Bi-weekly Seismic Call Agenda

Date: 2016-05-03

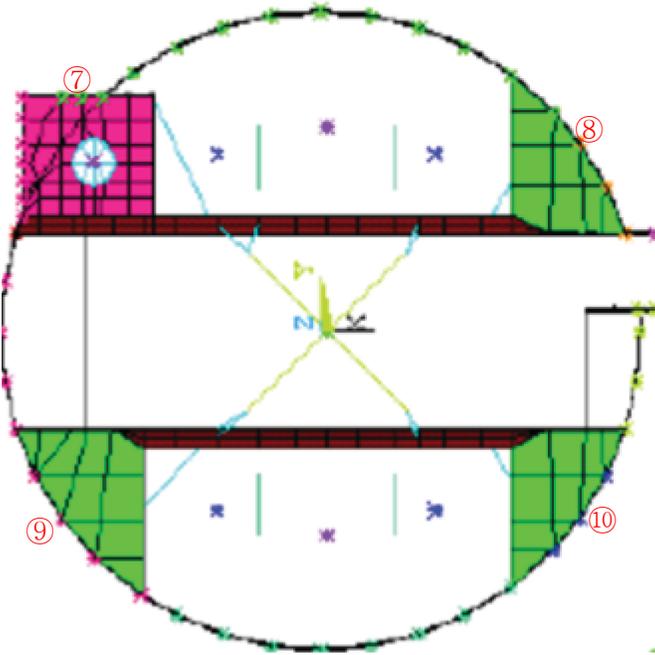
KHNP is to determine what slabs have been included in the live load study, re-perform the study if all slabs have not been included, and revise the RAI response to describe the modeling of all slabs and discuss the treatment of live loads with regard to those slabs (justify if excluded).

There are some small horizontal surfaces in the reactor containment building other than those horizontal surfaces between the secondary shield wall (SSW) and the containment shell. The small horizontal surfaces which are not between the SSW and the containment shell are modeled in the reactor containment building seismic analysis model. The following figure shows the horizontal surfaces modeled in the reactor containment building seismic analysis model compared to those those horizontal surfaces shown in DCD Tier 2, Figure 1.2-

2, "General Arrangement Reactor Containment Building Section A-A" on page 1.2-48, which was referred to by the NRC staff during the last bi-weekly seismic call.

In addition to the six horizontal surfaces shown in the figure above, four horizontal surfaces also exist in the reactor containment building, as shown in the figure below.

Since the ten horizontal surfaces labeled above are relatively small, the seismic live loads of those surfaces were ignored in

the last study for evaluation of seismic live load effect on seismic response of the reactor containment building.

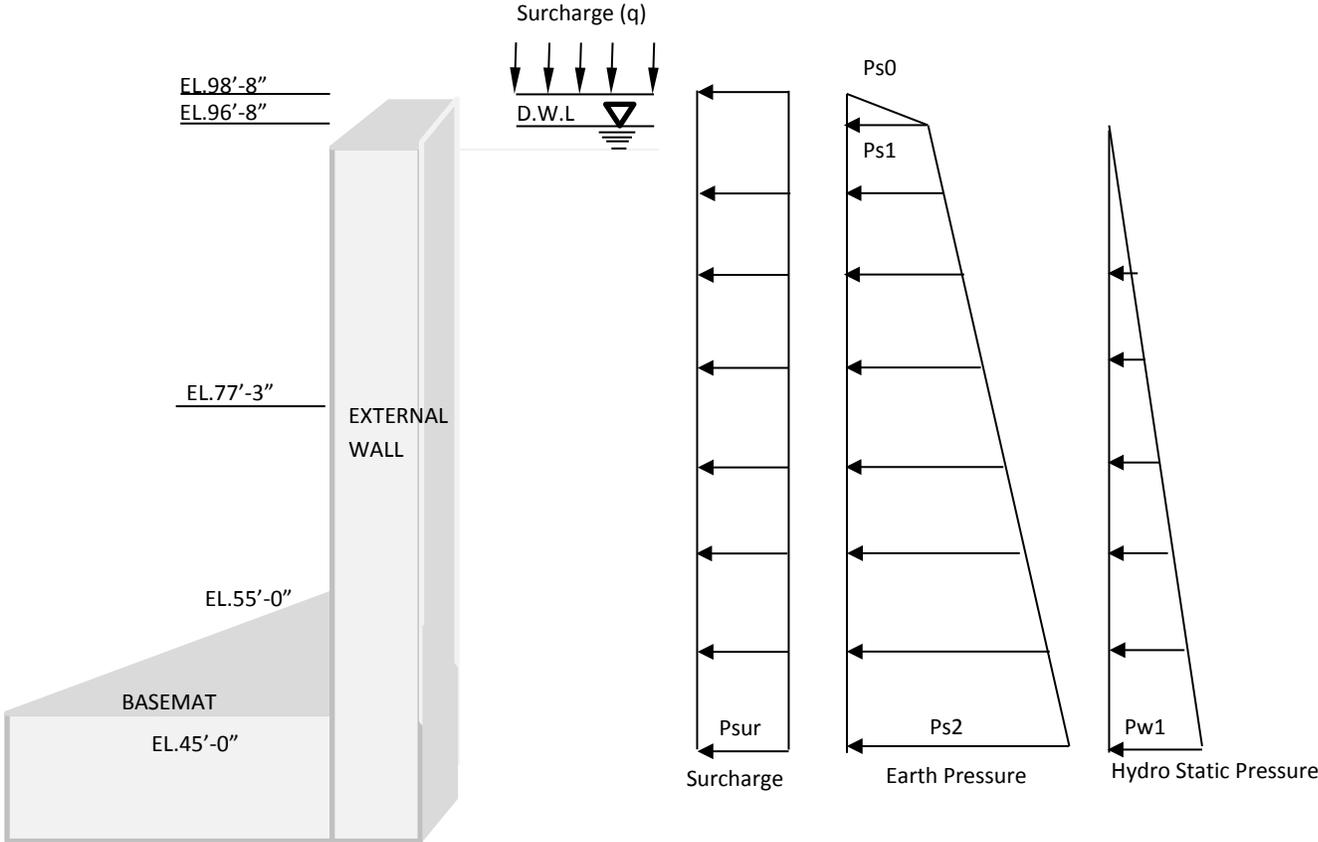
- 6. RAI 227-8274, Q 03.08.04-4
KHNP is to explain why L_g is only applied up to two feet below grade.

The soil and surcharge load (L_g) include hydrostatic pressure, surcharge load, and earth pressure. The response in RAI 227-8274 Question 03.08.04-4 is focused on the description of the water pressure, so the response explains the height for the hydrostatic pressure. The hydrostatic pressure is applied up to two feet below grade. Earth pressures are applied up to the grade level, as shown in the figure below.
